ADDENDUM NO. 1

RE: Sewer System Improvements – City of Stephens, Arkansas

ADDENDUM DATE: October 23, 2024

SEWER MAIN B
PLAN & PROFILE

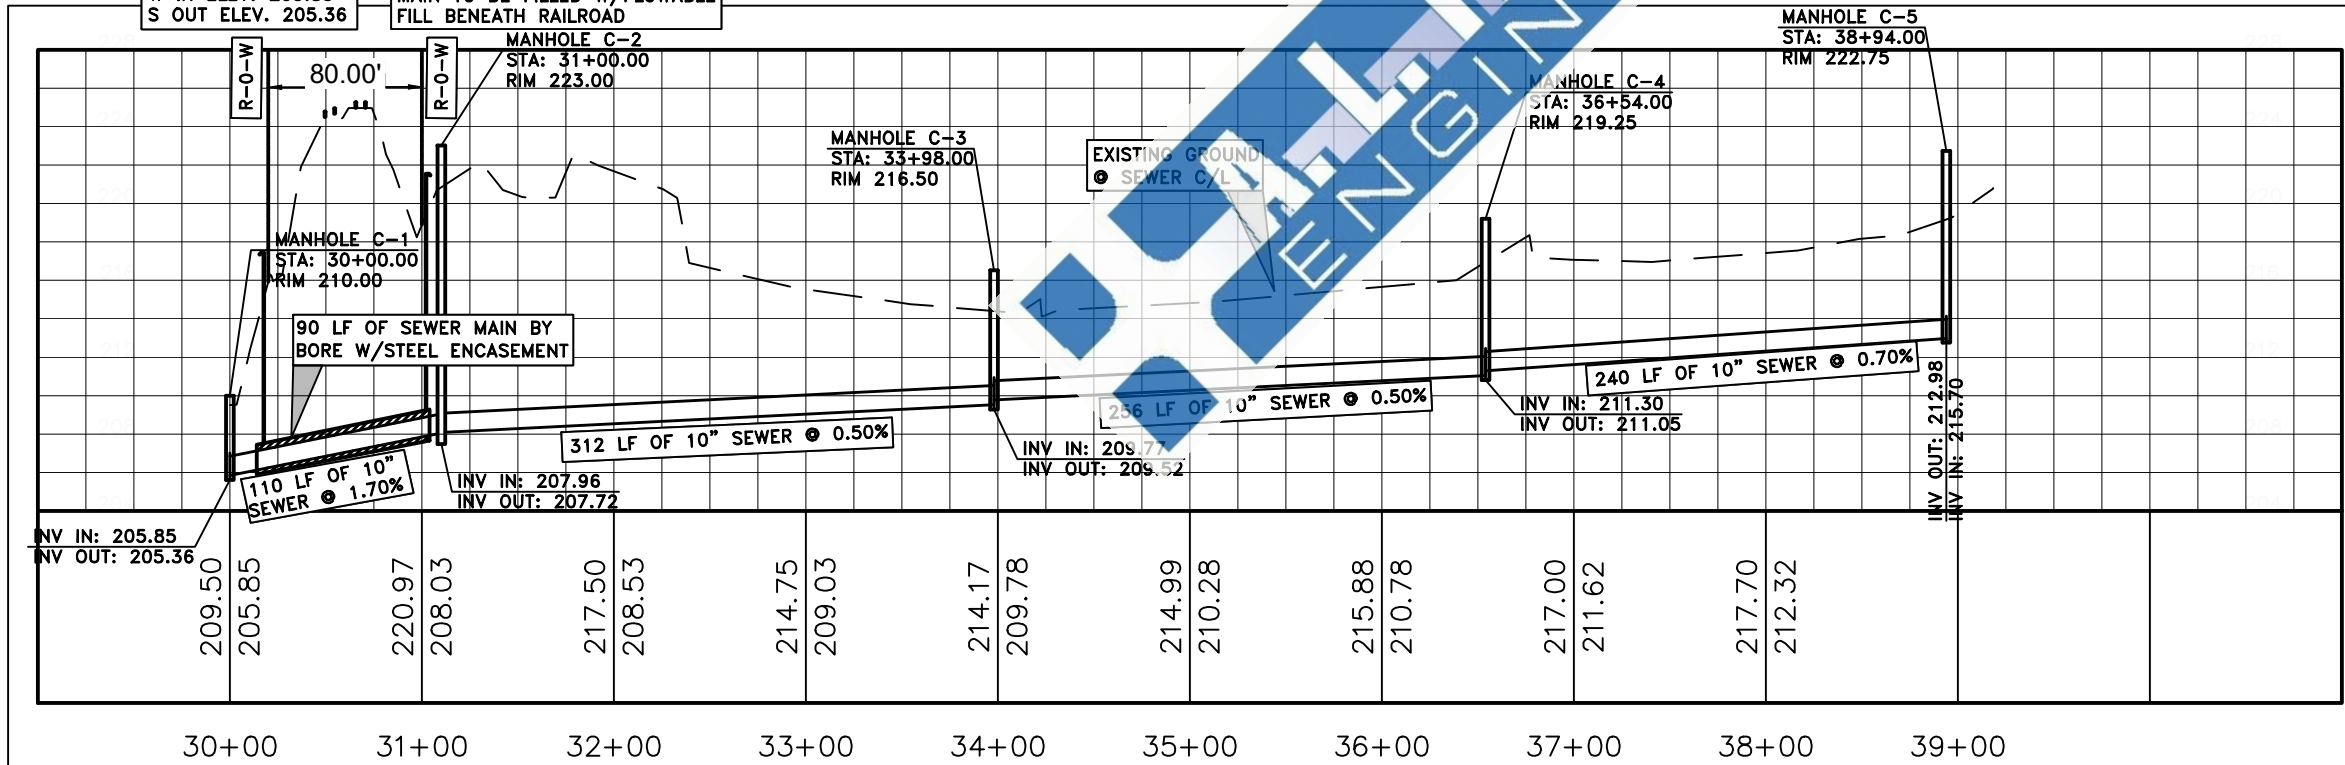
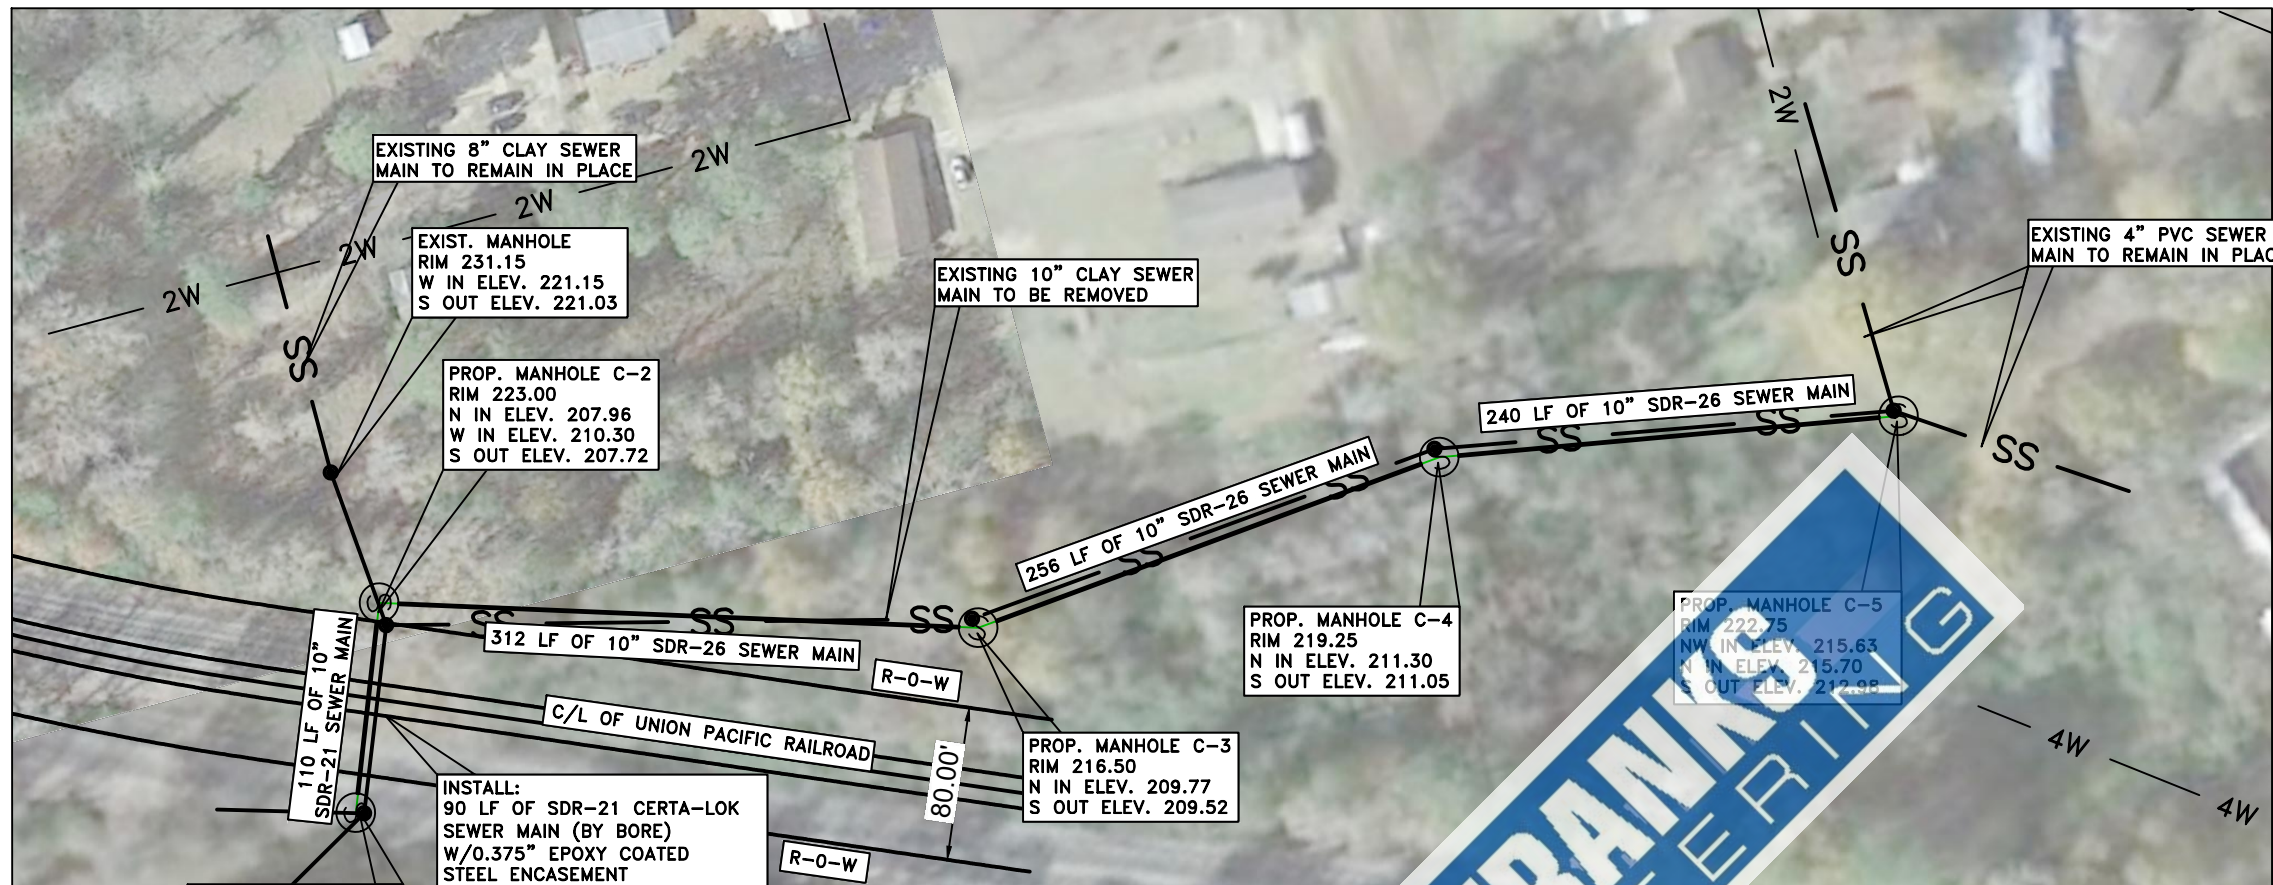
CONTRACTOR SHALL INSTALL VENT PIPES TO EXTEND 4' ABOVE GRADE.

ENCASEMENT PIPE SHALL BE SEALED ON BOTH ENDS.

9-30-24	1-REVISED PER ADH	CJM
10-22-24	2-RAILROAD CROSSING REVISED	CJM
Date	Revision	By

SEWER MAIN C
PLAN & PROFILE

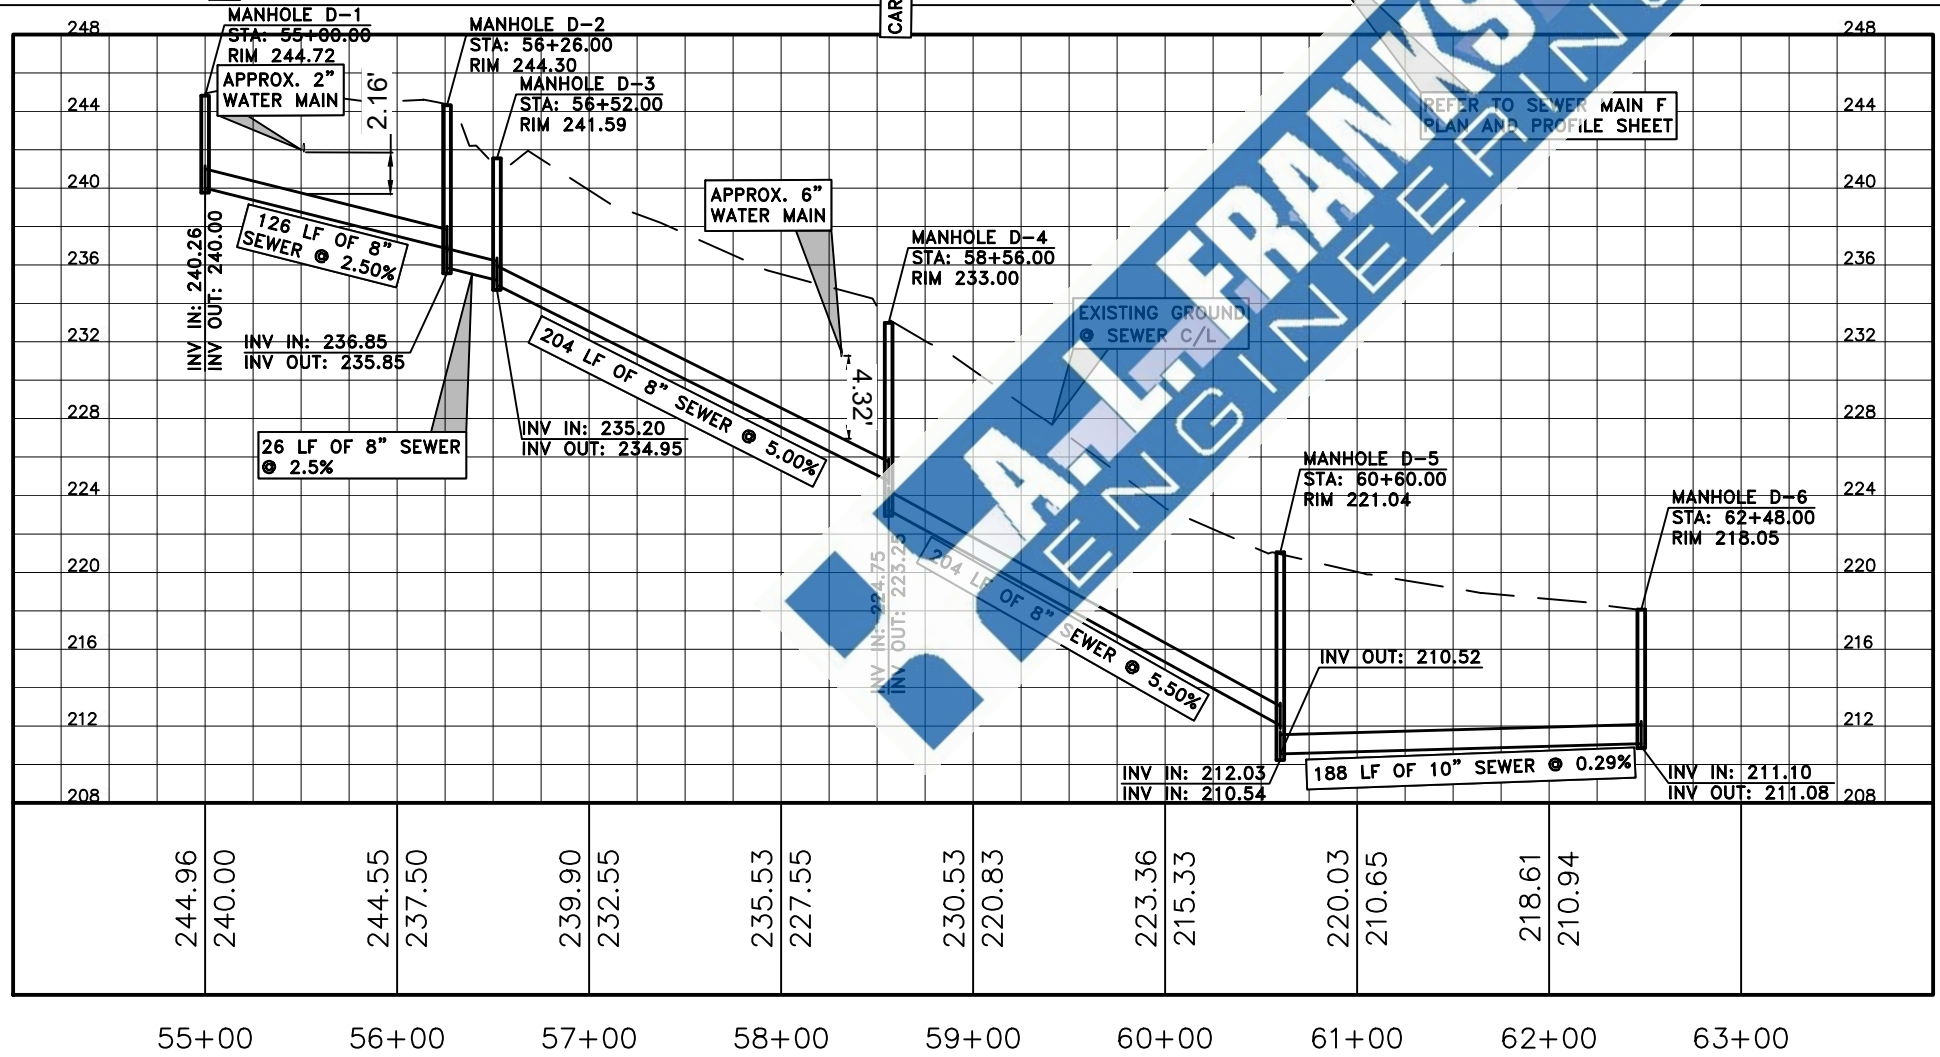
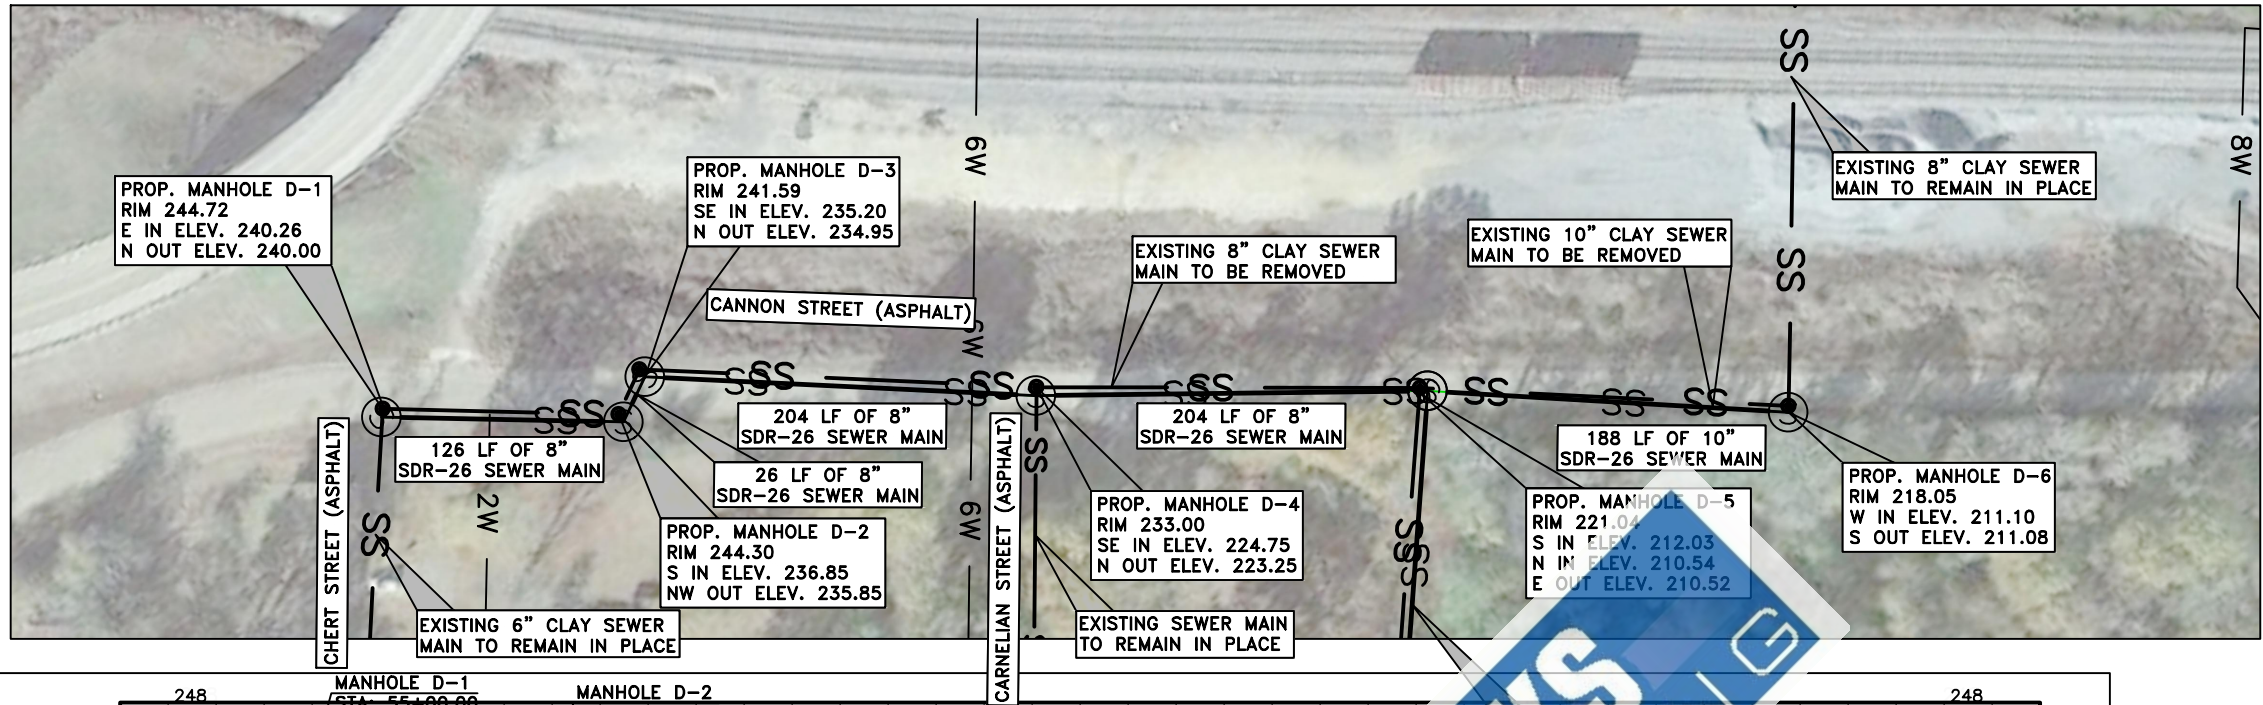
****DEDUCTIVE ALTERNATE #2****
ALL WORK FOR SEWER MAIN D
LESS PROPOSED MANHOLES D-5
& D-6 AND THE CONNECTING 10"
SEWER MAIN BETWEEN TO BE REMOVED
AS PART OF DEDUCTIVE ALTERNATE #2

SEWER MAIN D
PLAN & PROFILE

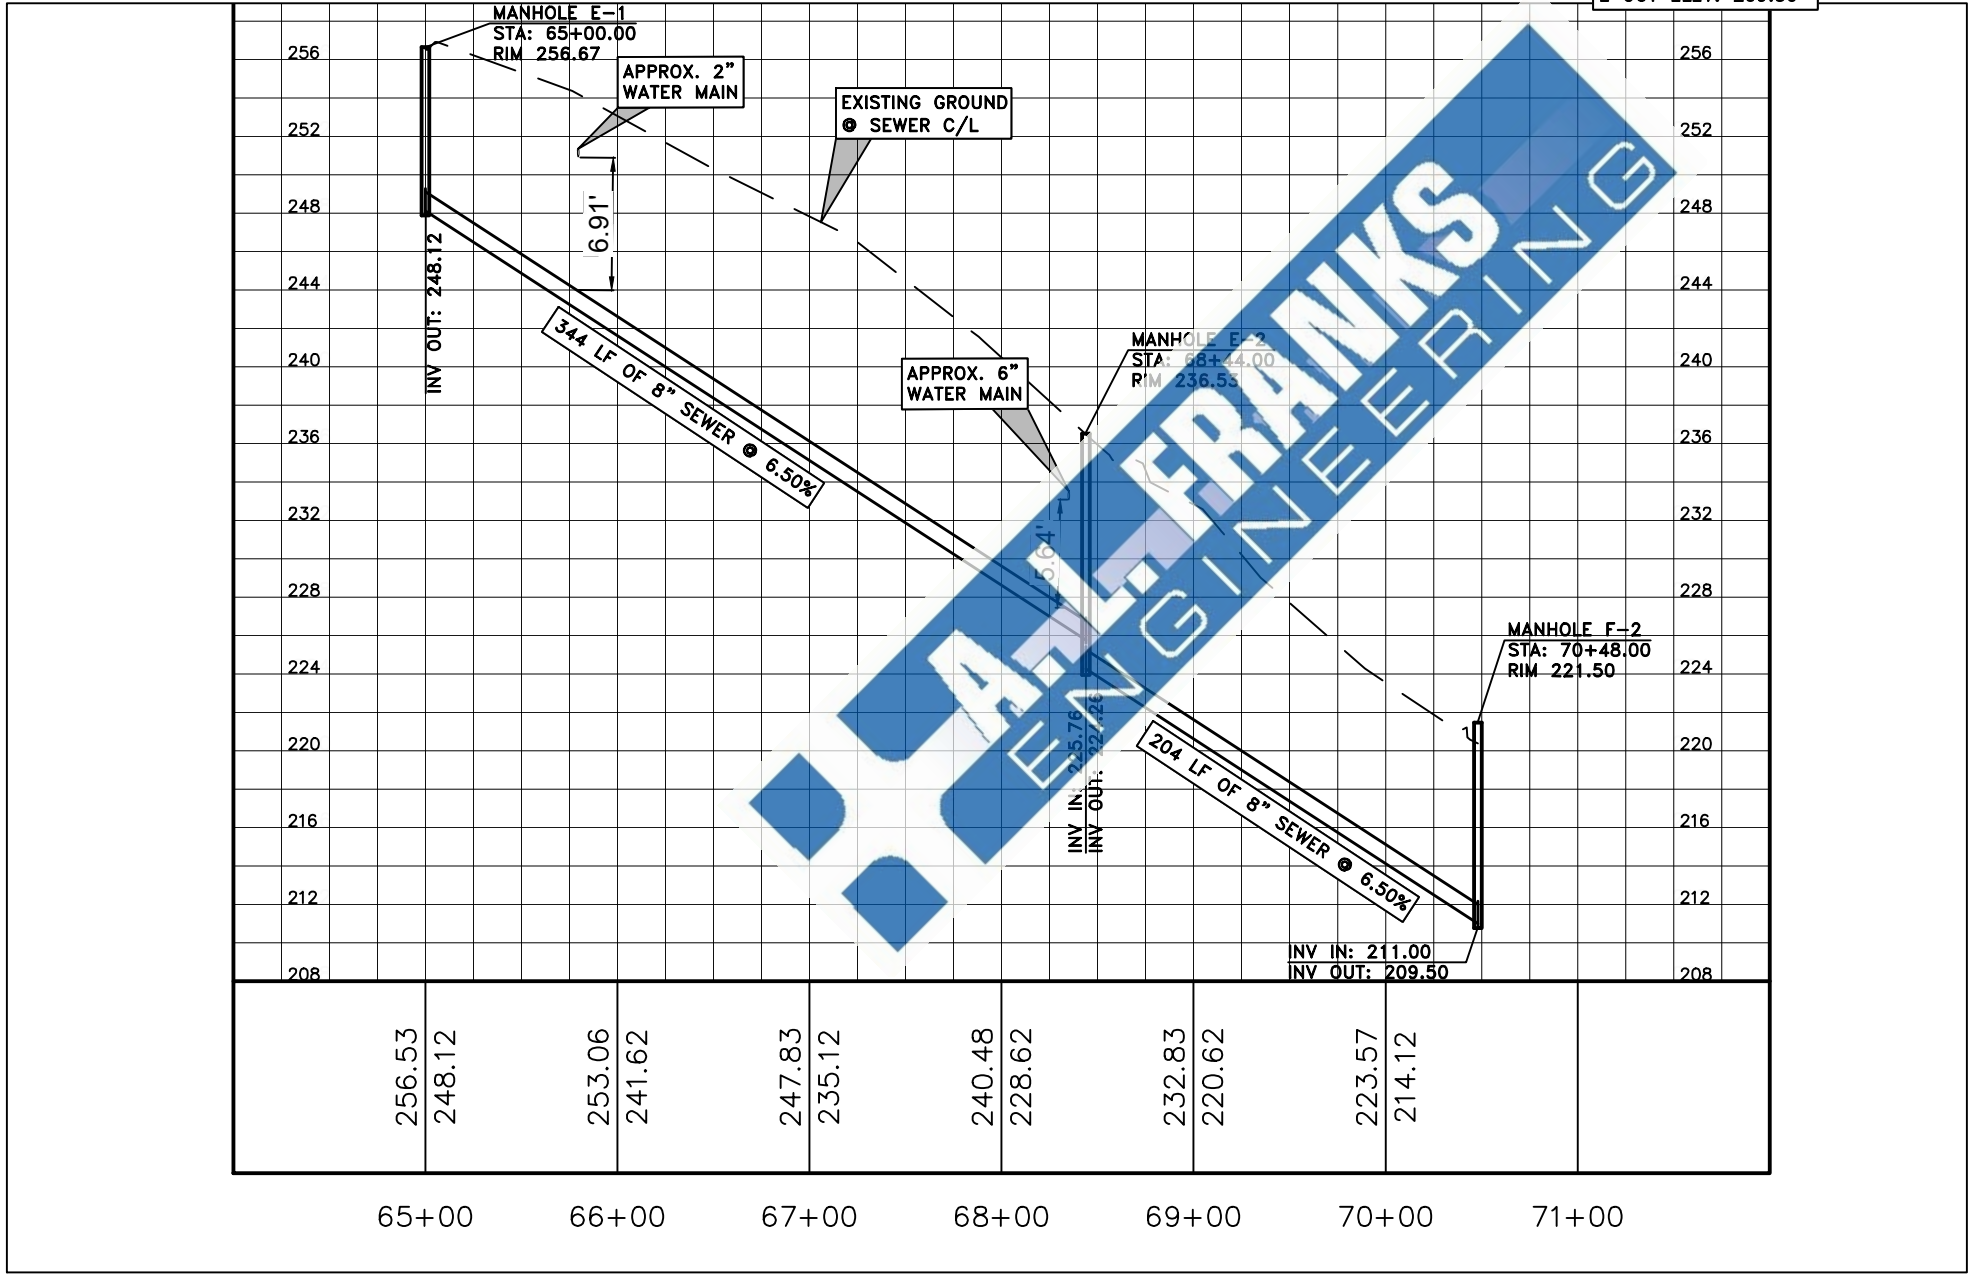
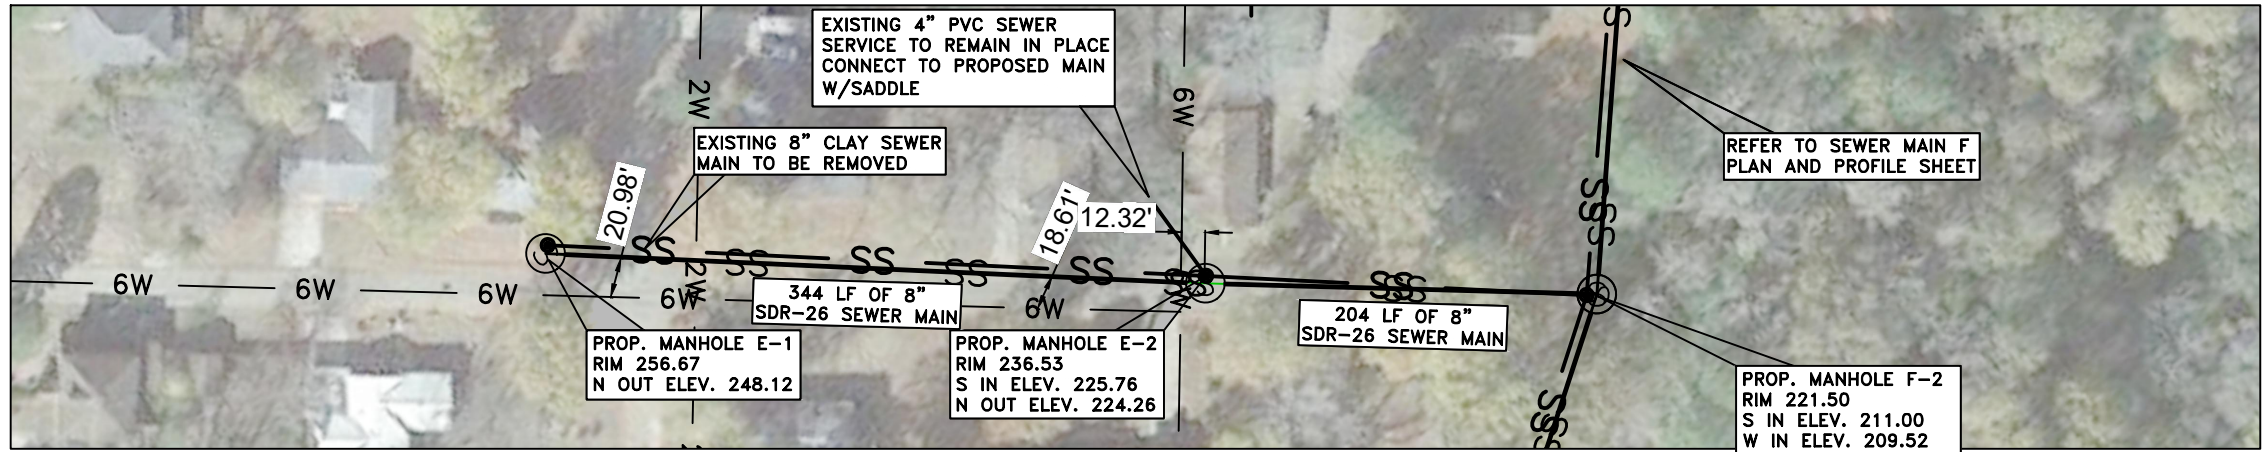
****DEDUCTIVE ALTERNATE #1****
ALL WORK FOR SEWER MAIN E
TO BE REMOVED AS PART OF
DEDUCTIVE ALTERNATE #1
